# London Luton Airport Expansion

**8.118 Applicant's Response to Issue Specific Hearing 4**  
**Action 7 - Updates on Road Safety Audits**

Application Document Ref: TR020001/APP/8.118

Figure 2.1: Locations of Problems Identified within the Audit

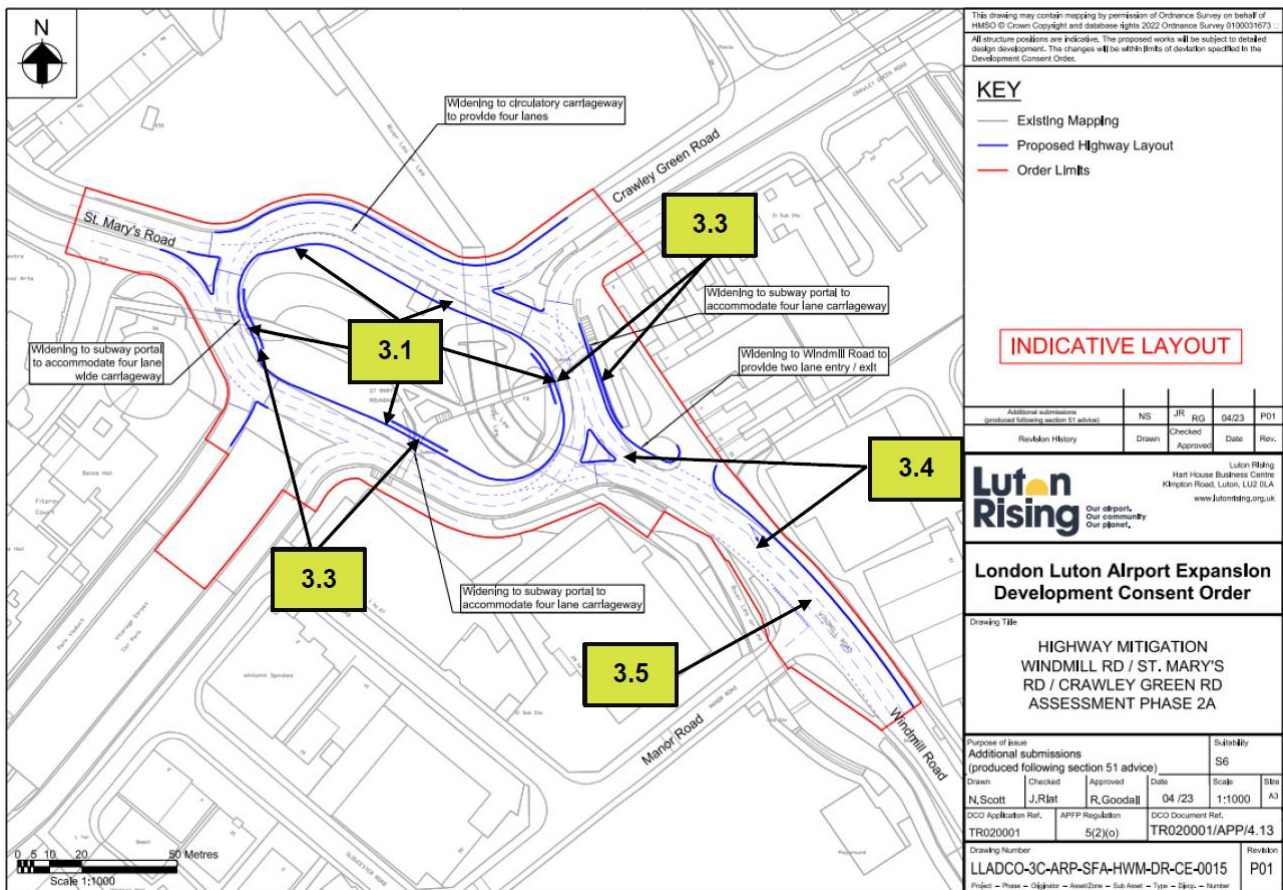
Ref.	RSA Problem	RSA Recommendation	Design Organisation Response	Overseeing Organisation Response	Agreed RSA Action
			undertaken to show HGV movements - see Figure 3.1.
